VALUE ENGINEERING REPORT

Spring Street Viaduct Replacement
Over CSX Transportation, Inc.
Project Nos.: BHNLB-9073-00(016) &
BRNLB-9073-00(018)
Fulton County
PI Nos.: 752086 & 752560
January 7, 2009

Georgia Department of Transportation
600 West Peachtree Street
Atlanta, GA 30308
(404.631.1770)

MACTEC Engineering and Consulting, Inc.
3200 Town Point Drive NW, Suite 100
Kennesaw, GA 30144
(770.421.3346)

TYPICAL SECTION #4
LOWER MARTIN LUTHER KING JR. DR.
STA. 12+54.74 TO 14+65.85

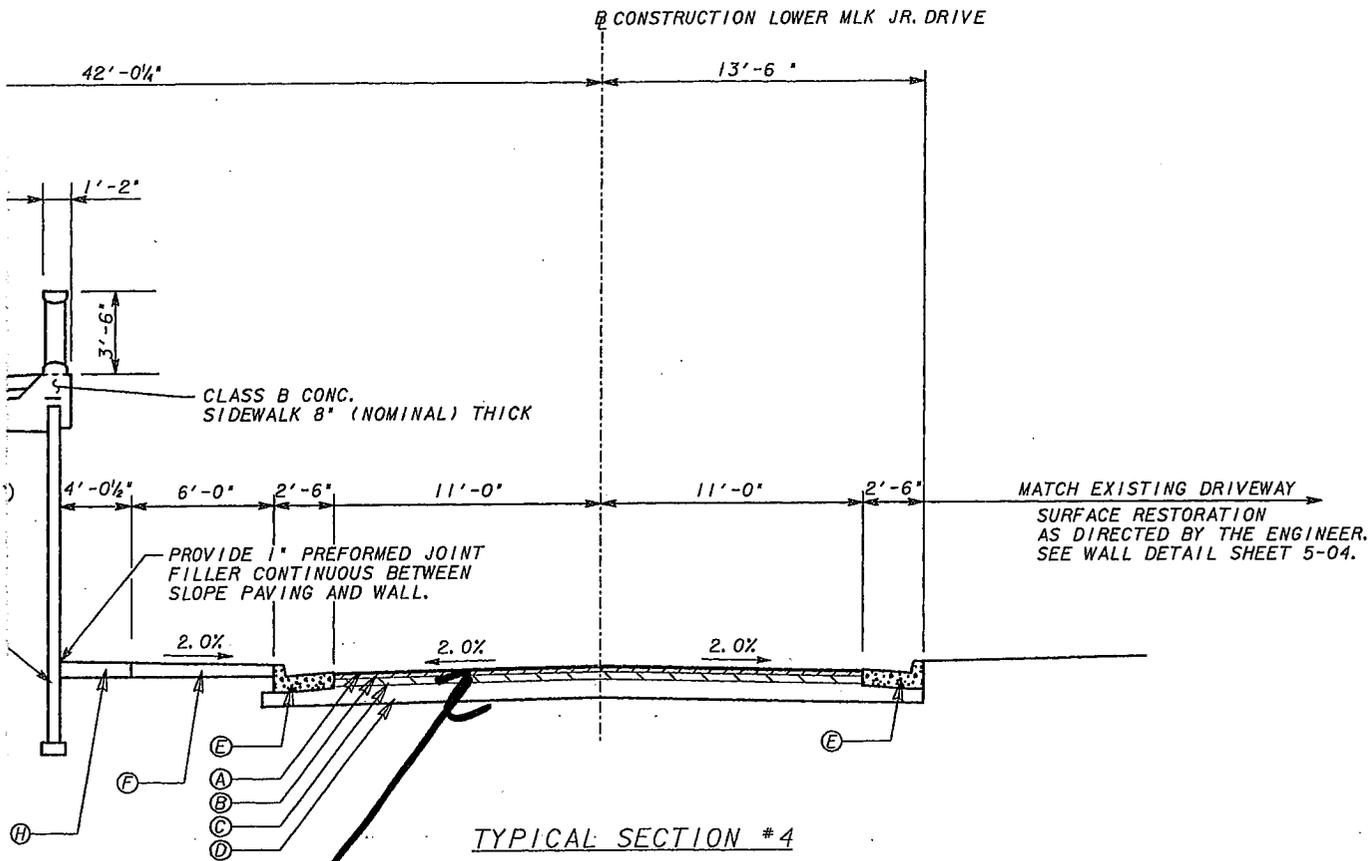
← REPLACE WITH GRASSED AREA

PLAN AND ELEVATION
SPRING STREET VIADUCT OVER
CSX TRANSPORTATION
BRN LB-9073-000018
FULTON COUNTY

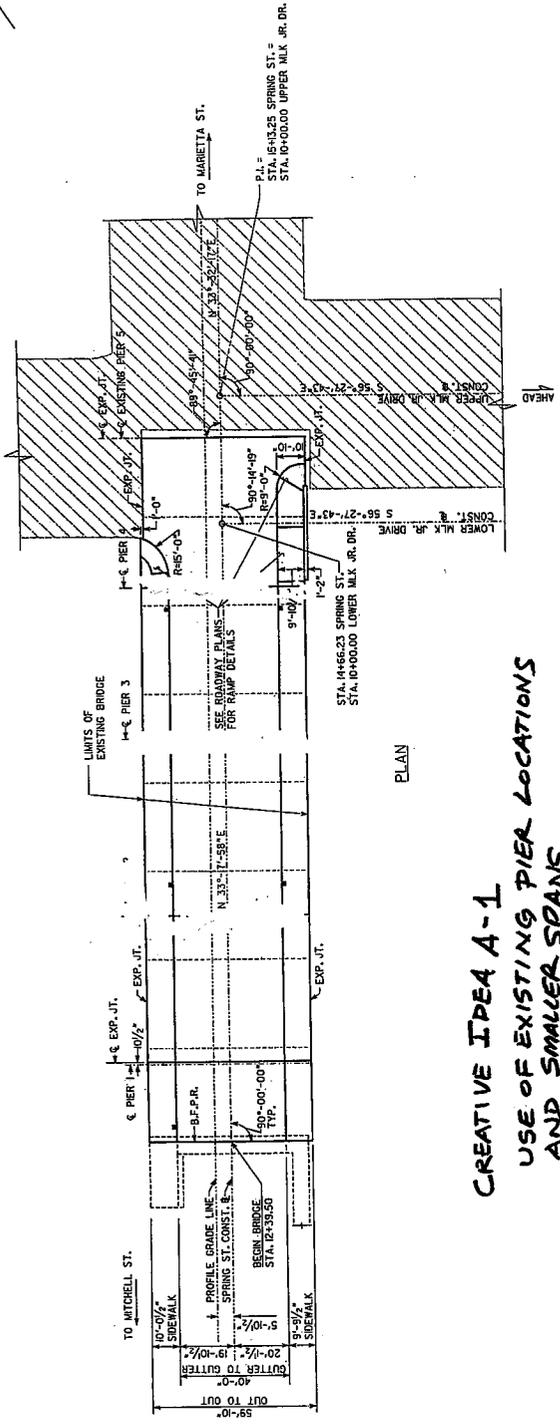
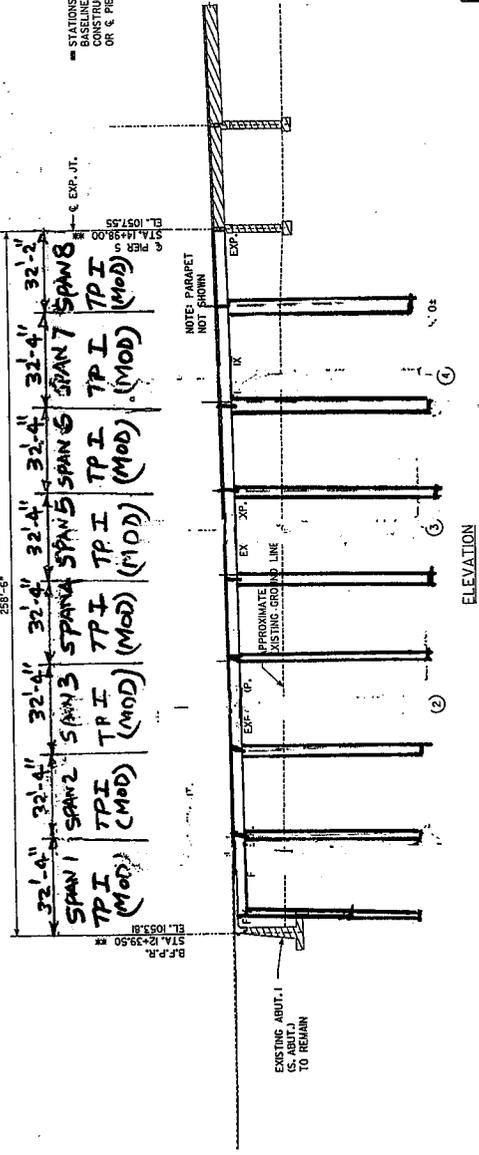
Use BT-54 PSC beams for new bridge span 14 and 15 arrangement. There is no change in the spacing (in kind replacement).

Item
H-2
Pg 2 of 4

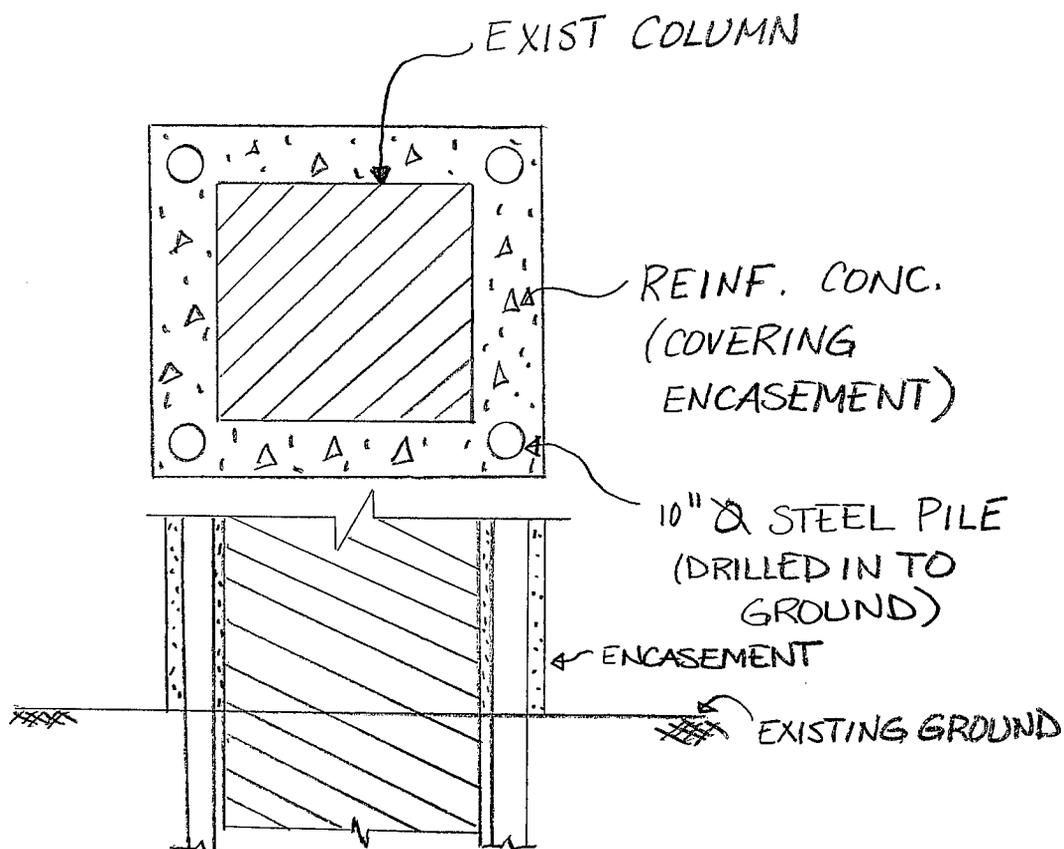
H-2 Use smaller spans by reusing existing column locations in Spans 1-5.
Use existing columns and locations to minimize disturbance of new pier locations in this area. Existing columns are enhanced with drilled steel piles as shown in the sketch in the item development.
